City of Richmond
Planning and Development Department

Report to Committee

To: Planning Committee **Date:** April 4, 2011
From: Brian J. Jackson **File:** ZT 09-492885
Director of Development
Re: **Application by Oval 3 Holdings Ltd. and Oval 4 Holdings Ltd. for Zoning Text Amendment at 6051 and 6071 River Road and Road B to Amend "High Rise Apartment and Olympic Oval (ZMU4) – Oval Village (City Centre)"**

RIVER GREEN PARCEL 3 & 4 - PROPOSED DEVELOPMENT CONCEPT PLAN - FEBRUARY 18, 2011

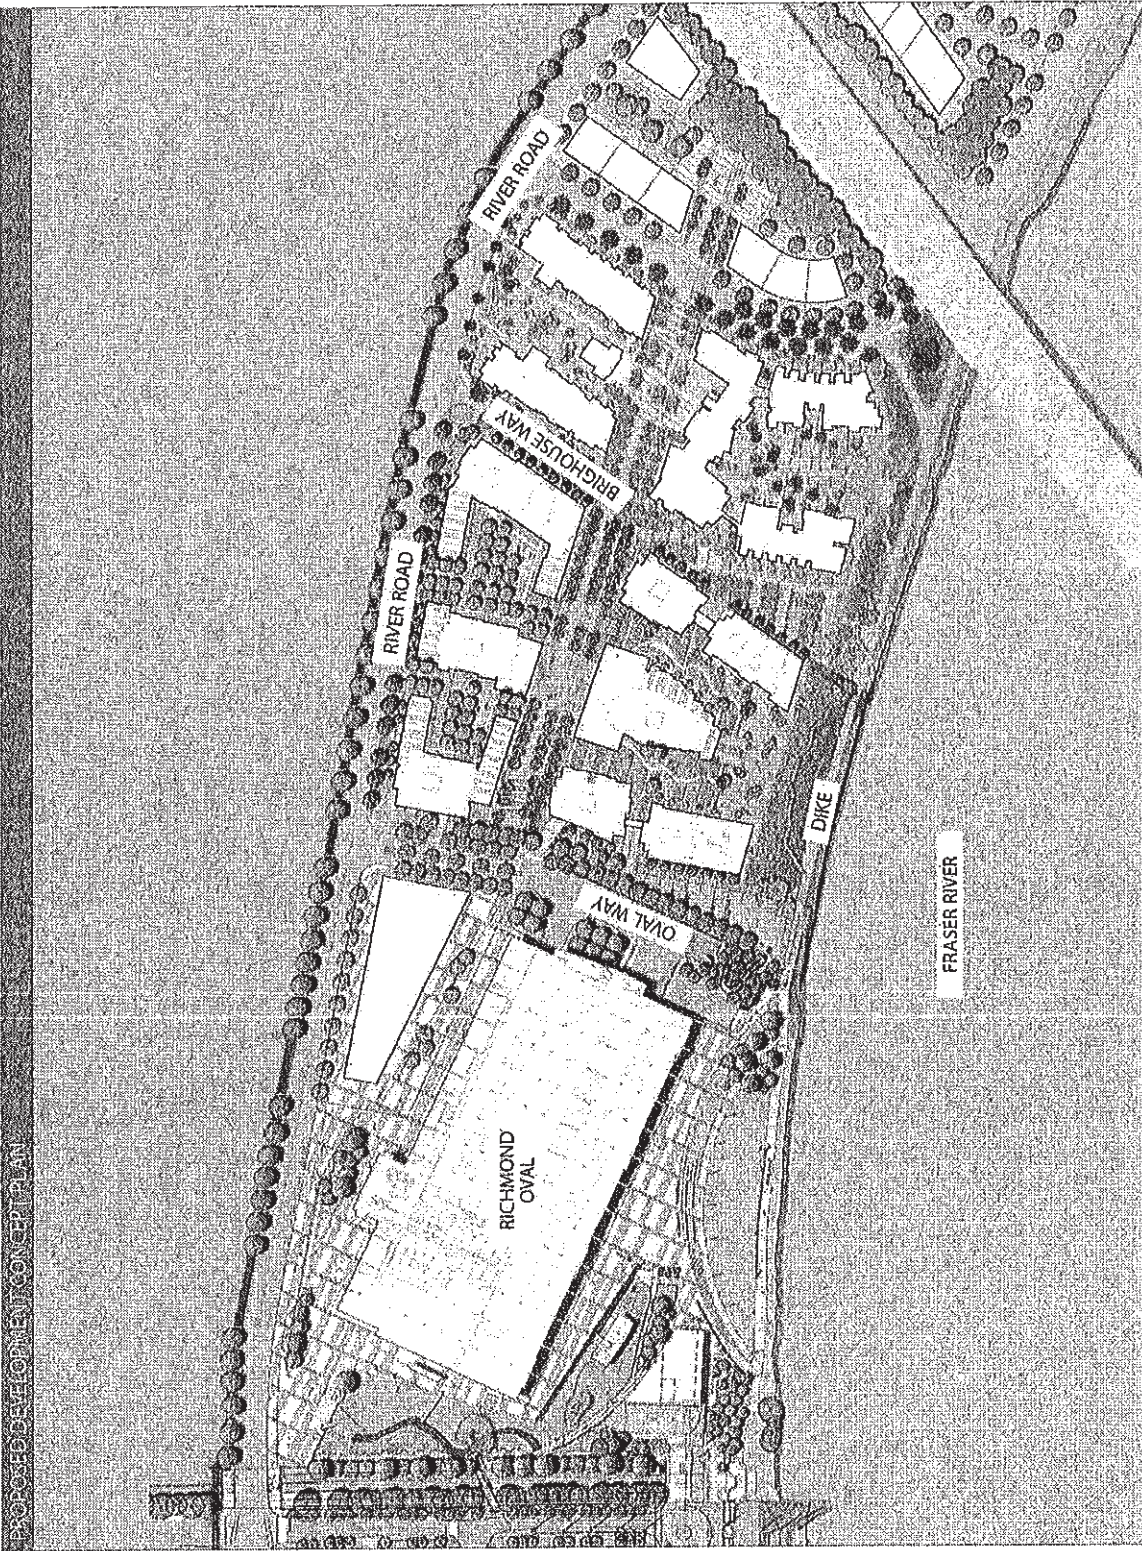
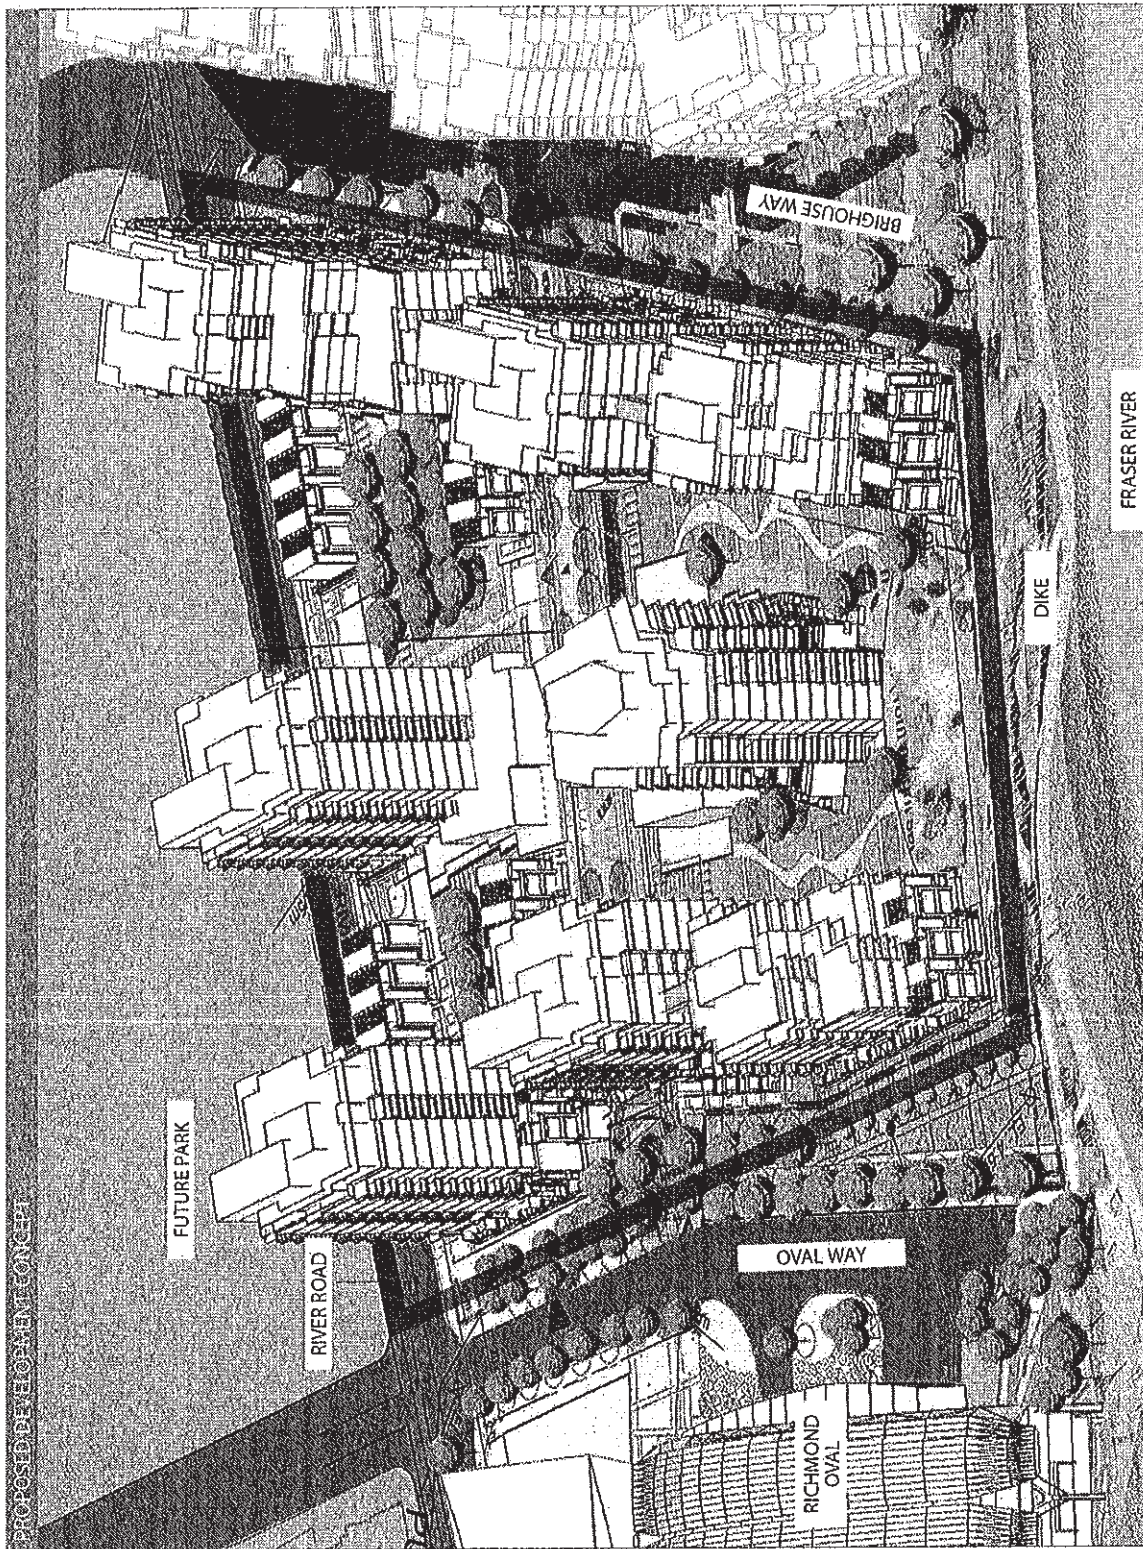
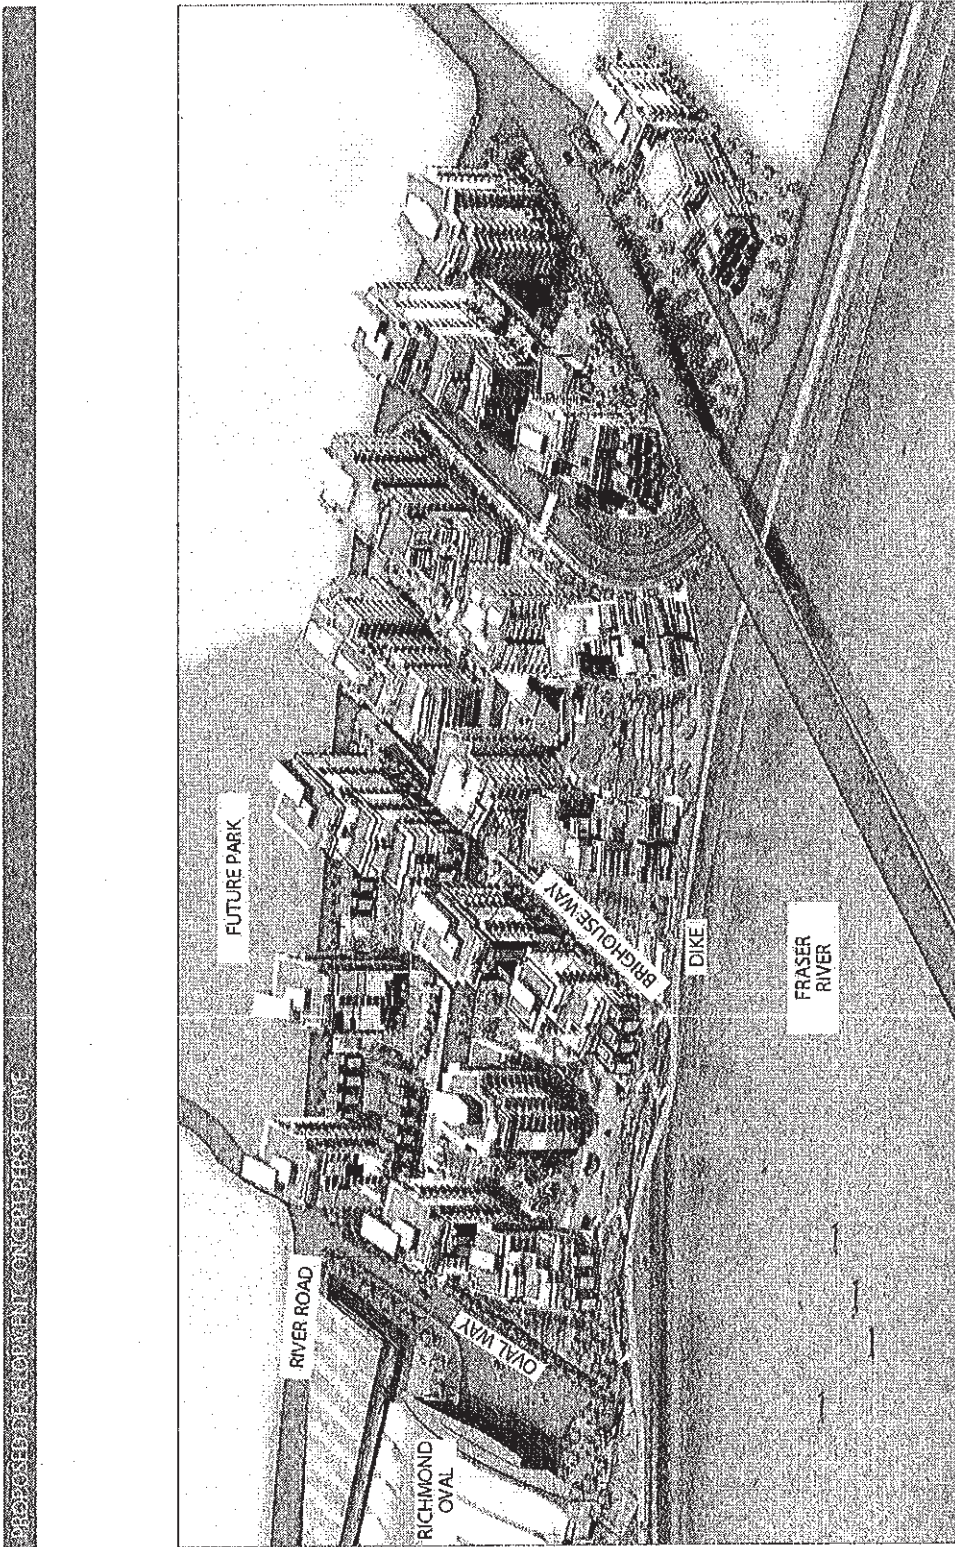
The development concept’s proposed closure of Road B provides for new park space and an enhanced greenway along Oval Way (“Samuel Brighthouse Boulevard”), but the frequency of public access points along the riverfront is reduced and the grade change at the east end of the east-west promenade is abrupt and could discourage public entry to the site. This situation is mitigated in part by the development’s proposal to align the site’s buildings perpendicular to the river to provide for north-south view corridors. In addition to this, via the DP process the developer should demonstrate that:

- Proposed view corridors are extended to grade to facilitate meaningful views for the public/pedestrians;*
 - The east end of the east-west promenade is designed to be more open, inviting, and accessible (i.e. stairs and switchback ramps are discouraged); and*
 - The “publicness” of this riverfront area is enhanced by “blurring” the boundary between on-site and off-site open spaces and, where possible, permitting public pedestrian access across or onto the development sites.*
- *Objective #2:* Parking should be concealed below grade to increase accessible, on-site open space, provide for more attractive, pedestrian-friendly streetscapes, and ensure a seamless transition between on-site open spaces, public streetscapes, and the riverfront park.

The development concept provides for extensive on-site open space over parking; however, the developer’s proposal to provide more parking than that required under the Zoning Bylaw could result in abrupt, unattractive grade transitions, especially along fronting streets, walkways, and open spaces. Steps should be taken via the DP process to ensure grade transitions are attractive and the quality of the public realm is not compromised.

The development concept locates lower buildings near the riverfront and minimizes shadowing of the dike in the afternoons and evenings (at the equinoxes and through the summer months); however, there is little variation in tower height (i.e. 4 @ 13 storeys and 2 @ 12 storeys) and there appears to be significant shadowing of on-site open spaces. Via the DP process, the developer should work to create a more interesting skyline (i.e. greater variation in building heights, variations in roof forms) and further reduce shadowing of useable outdoor on-site and off-site spaces.

The development concept proposes a minimum tower spacing of 24 m, rather than the 35 m spacing recommended via the City’s original planning of this area and the CCAP.

While the proposed smaller spacing may provide for adequate privacy between fronting buildings, when considered in combination with the minimal variation in tower height (described above), it could make the development appear “wall-like”. Via the DP process, the developer should work to increase the separation between towers and/or increase the staggering of towers, increase variations in tower heights (as noted above), and incorporate other measures that will counter the development’s potential “wall-like” appearance and increase its porosity.

The development concept for the subject site provides for an informal arrangement of park-like spaces oriented towards the river on the north lot, and more urban, inward focussed outdoor spaces (i.e. courtyards) on the south lot. This approach appears to respond well to the challenges/strengths inherent in each lot (e.g., changes in grade) and provides the opportunity for a varied and interesting landscape vocabulary. Via the DP process, the developer should work to ensure that:

- Grade changes and massing on the north lot are designed to maximize views to the river and mountains, including public views from the East-West Promenade; and*
 - Streetwalls defining the perimeter of the south lot are designed to be visually interesting (e.g., variations in form/character/colour/materials, breaks in the walls providing for public visual/physical access), contribute to a pedestrian-friendly public realm (e.g., attention to human scale, significant planting, high-quality landscape features and street furniture), and address the future neighbourhood park south of River Road (as per the CCAP).*
- *Objective #6: Water features should be integrated into the development sites to enhance their relationships with the riverfront landscape and opportunities for special green-building/storm water management features.*

The development concept provides for an artificial lagoon between its buildings and the riverfront park. While the concept could be very attractive and provide a desirable “buffer” between the park and the development’s dwellings, no information is provided regarding the intended design/operation of the water feature, how it will be made affordable for residents to maintain and operate over the long-term, or how it will be tied into abutting public areas. These considerations should be addressed via the development’s DP review and approval processes.

RIVER GREEN PARCEL 2 & 4 PRELIMINARY PARK AND GREENWAY CONCEPT FEBRUARY 14, 2011

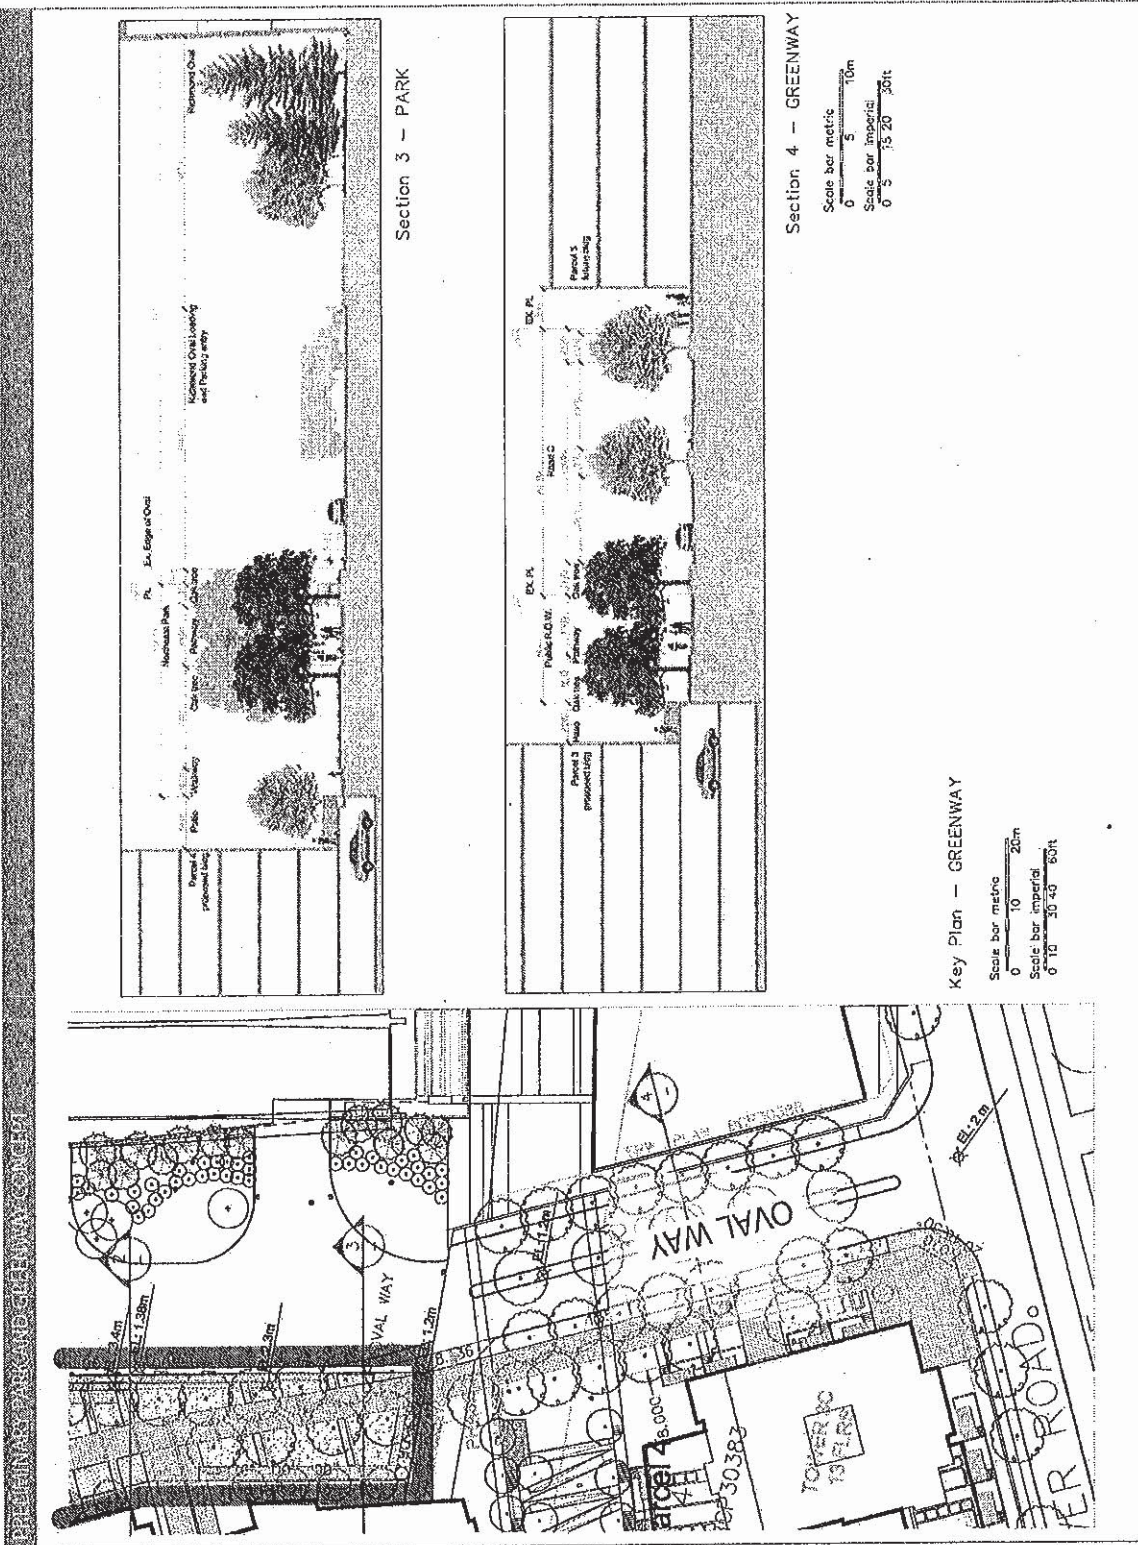
- a) Park Development: The proposed City lot is intended to be developed, at the developer's sole cost, for park uses (e.g., pedestrian and bike paths, special tree planting to commemorate Samuel Brighthouse) and emergency/service vehicle access to/from the dike, as per the attached "Open Space Terms of Reference". (**Attachment 8, "Schedule C"**).

The area of the proposed park lot is equivalent to that of existing Road B, (2,985.2 m² / 0.74 ac); and, while this is not large:

- Public open space will be extended south to River Road (and a future neighbourhood park south of River Road, as per the CCAP) via an 8 m wide Public Right of Passage right-of-way secured for use as a landscaped greenway across the Oval Way frontage of the developer's two proposed lots;

- The proximity of the lot to the dike, the Richmond Oval, and the proposed "Fish Trap Way" public open space at the foot of Brighthouse Way will enhance its use as park and the public use/enjoyment of those adjacent public spaces/amenities; and

- The proposed City lot and associated greenway along the Oval Way frontage are better suited to the establishment of the "Samuel Brighthouse Boulevard" than the previously identified location for this feature (i.e. Road B), as they will not be shared with general purpose traffic and no portion will be constructed over a parking structure, thus, making them better able to accommodate large-growing trees.

Staff note that the developer requires a driveway across the proposed greenway to provide access to/from the proposed north residential lot. While this is undesirable, the alternative would be a public road crossing the greenway, which could be more disruptive. Staff are satisfied that via the Development Permit and Servicing Agreement design/construction processes, any potential impacts on public amenity and safety resulting from the driveway can be minimized.

On this basis, staff support the proposed City park/lot, and recommend that "no development" covenants are registered on the developer's two proposed residential lots requiring that prior to Development Permit issuance, the developer must enter into the City's standard Servicing Agreement, secured by a Letter(s) of Credit, to design and construct, to the satisfaction of the City and at the developer's sole cost (i.e. DCC credits shall apply only to eligible "park development" improvement within the City-owned park lot):
